Application No. 24337
Permit No. 19447
Certificate No. 22124

DR. SAMUEL WERNER RESERVOIR AND DAM AT THE MERLIN SANITARIUM

INSPECTION REPORT

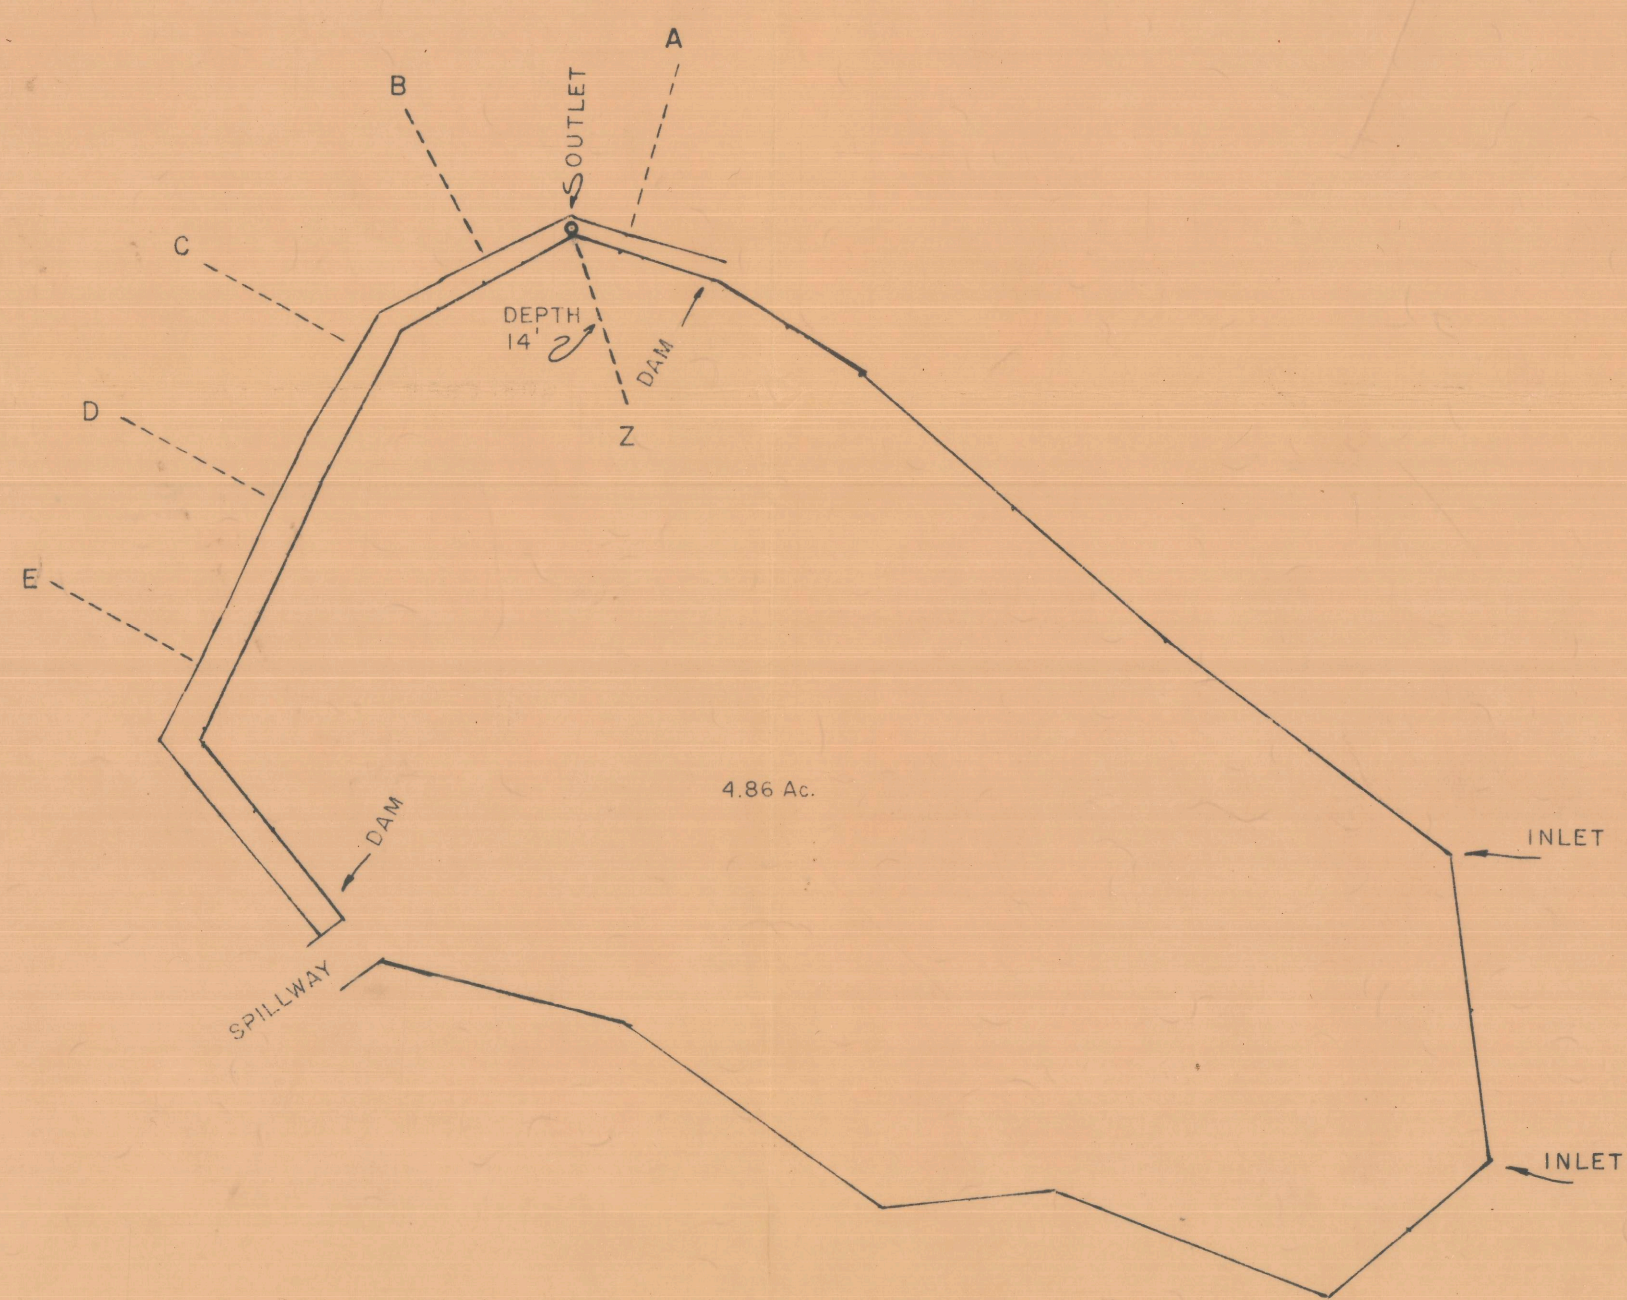
The plans for this dam specify a crest width of 15 feet. In most areas of this structure the crest falls far short of 15 feet. Furthermore, the downstream slope is to be 2:1. The slope you show is as steep as 1.2:1 but never less than 1.5:1. This dam has definitely not been constructed in accordance with the plans and specifications submitted by the applicant and as shown on the plans which were prepared by Ray N. Cruden in October of 1949.

I do not wish to create any undue hardship on Dr. Werner, however, I feel that in operating this structure close to the top creates a hazard, and in areas where the cross sectional of the dam has been reduced through faulty construction, the water level should at no time be closer than two feet to the crest. I believe I instructed you that the water level was to be two feet below the crest of the dam at the lowest point that yielded a crest width of 8 feet.

Furthermore, during the wintertime or the period from November through March or April, as local hydrological conditions govern, I feel that all the boards in the spillway should be removed.
